**BLOOMINGTON PLAN COMMISSION
STAFF REPORT
Location: 105 & 111 W. 4th Street**

**CASE #: SP-04-20
DATE: March 9, 2020**

REQUEST: The petitioner is requesting site plan approval for a new parking garage in the Commercial Downtown zoning district.

Subject: SP-23-19: City of Bloomington, Fourth Street Parking Garage
105 & 111 West 4th St., and 222 South Walnut St.

North Elevation

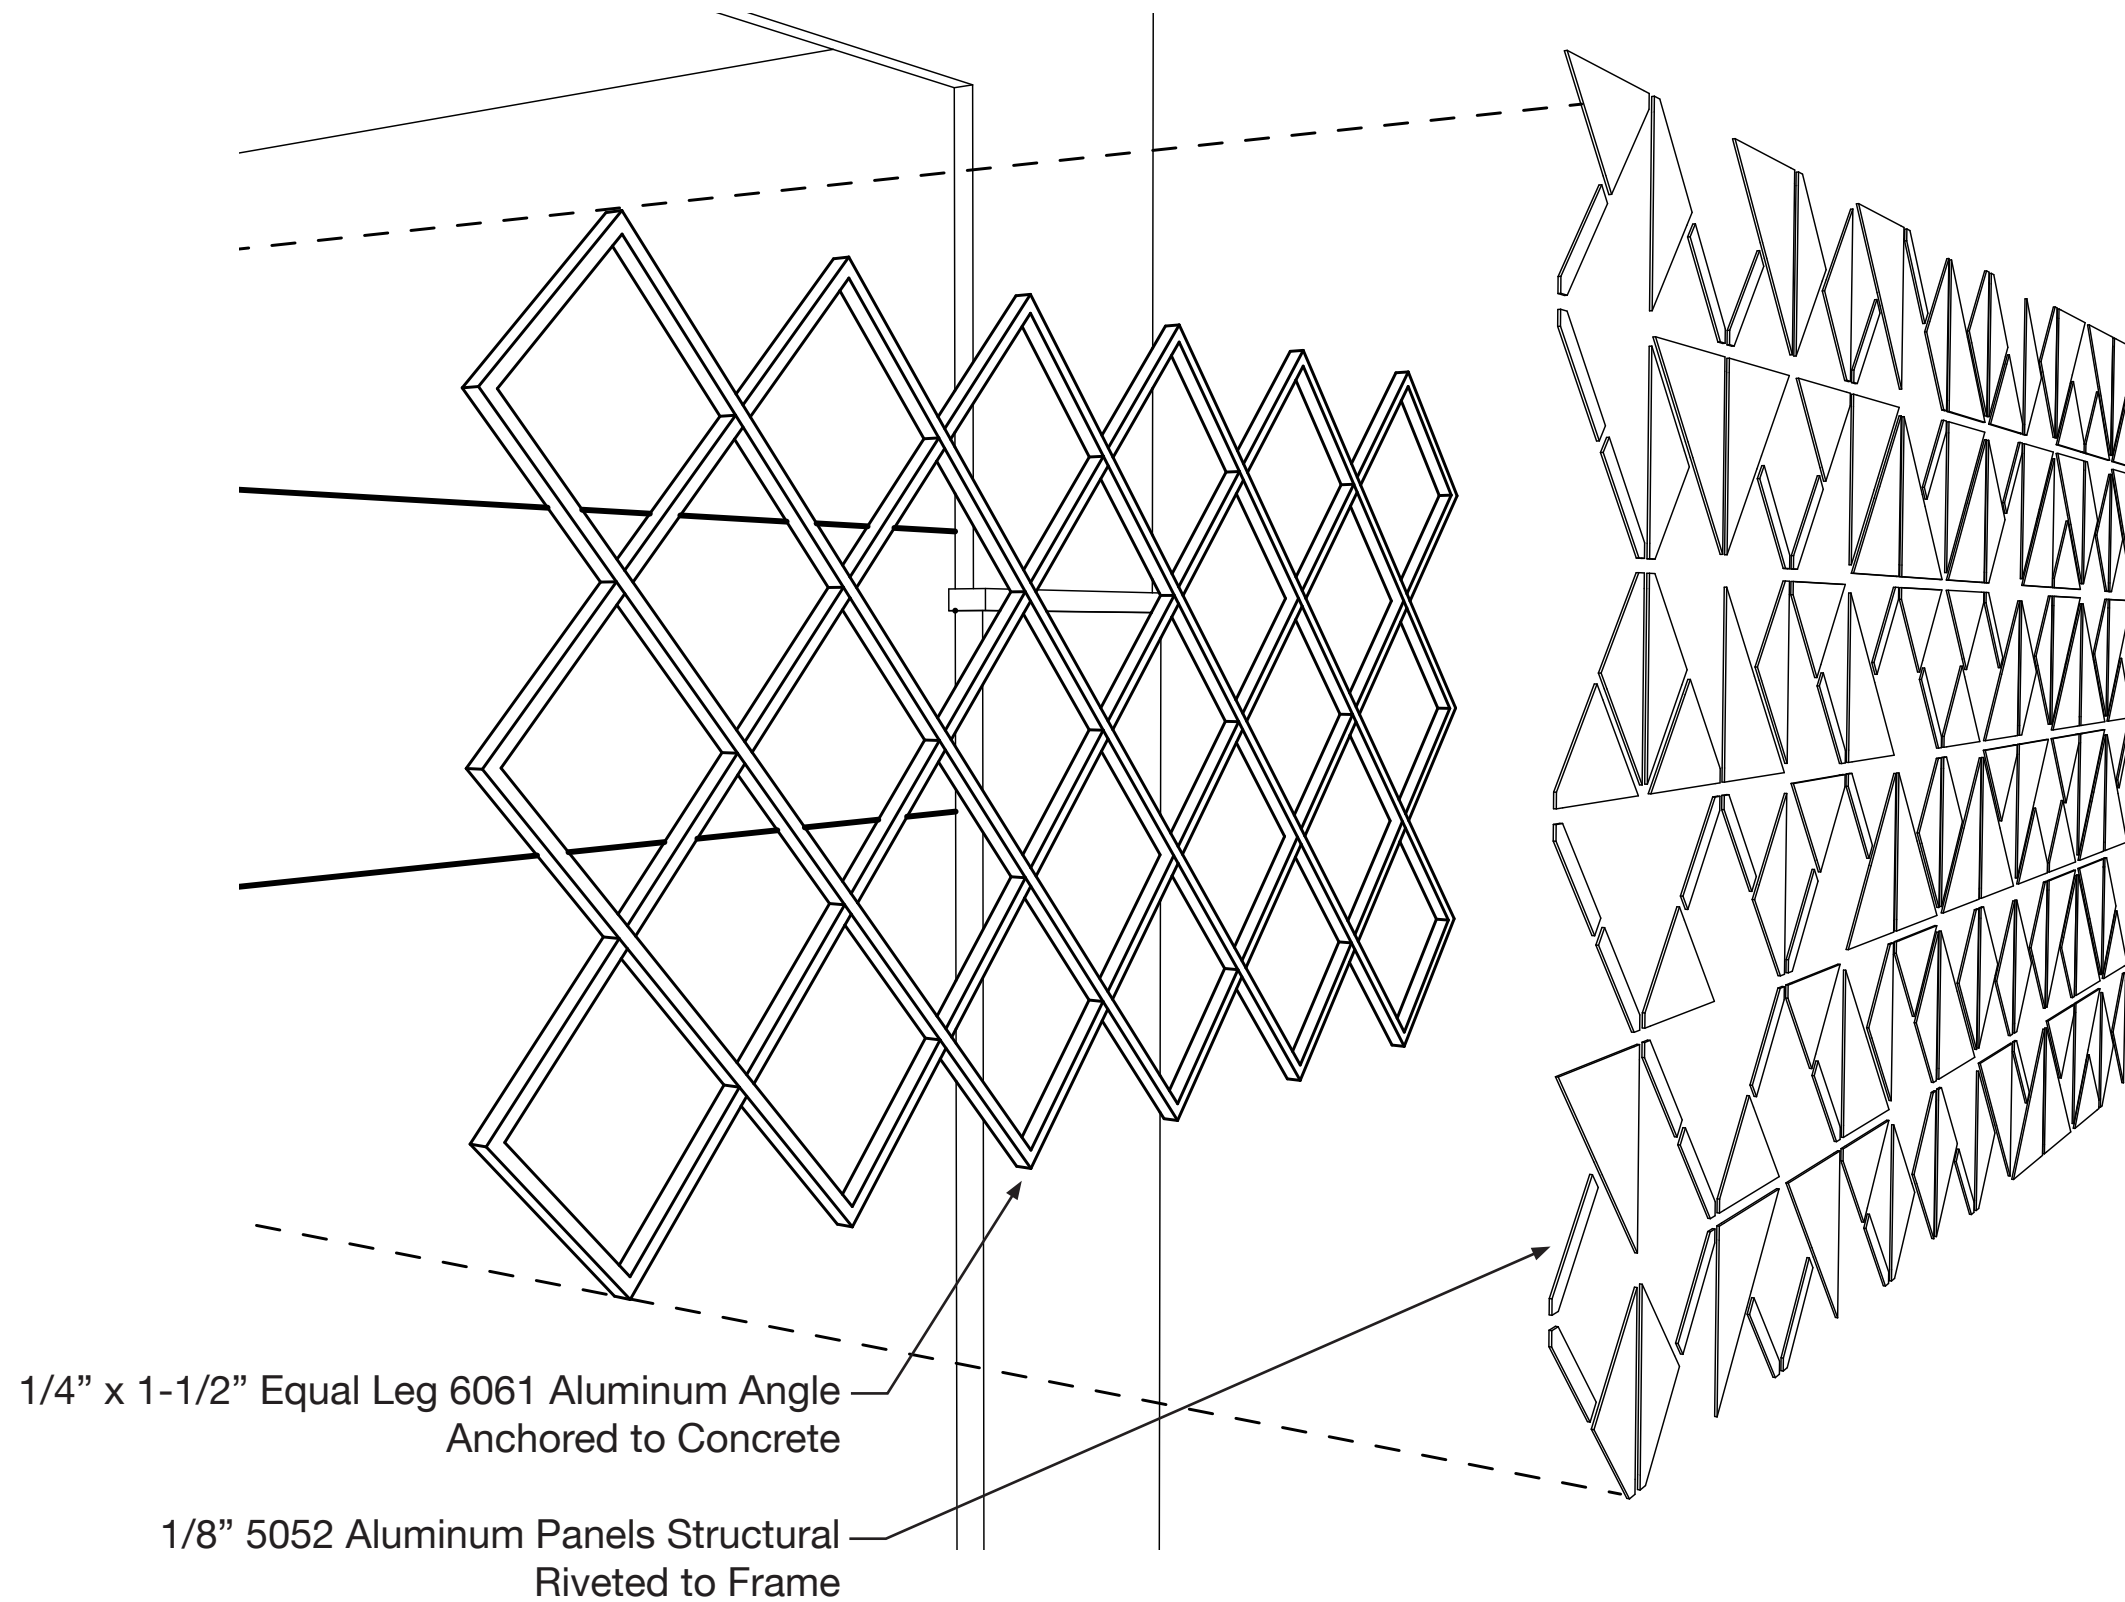
The DCO sets a minimum first floor void-to-solid requirement of 60%, consisting of transparent glass or façade openings, for facades facing a street. Upper stories are required to have a minimum of 20% void area. The DCO also requires a height-to-width ratio of 1.5:1 for upper story windows and the incorporation of lintels and sills. Because the parking garage is being designed with open air facades to facilitate increased natural light and air circulation, the design of the structure does not support these more traditional building design requirements. The petition does not meet these requirements. The Department has asked for additional windows on the northwestern stair tower facing 4th Street, and a condition of approval has been included.

6. All exterior modules shall be treated with the art installation urban fabric that is shown as part of this development.
7. The petitioner shall include additional windows on the 4th Street side of the northwest stair tower.
8. The commercial space entrances of the building will be required to meet pedestrian entrance standards related to the inclusion of awnings and/or canopies.
9. The opening along 4th Street at the northeast corner of the building shall be improved to allow for passage of only pedestrian and bicycles into the building through that entrance.
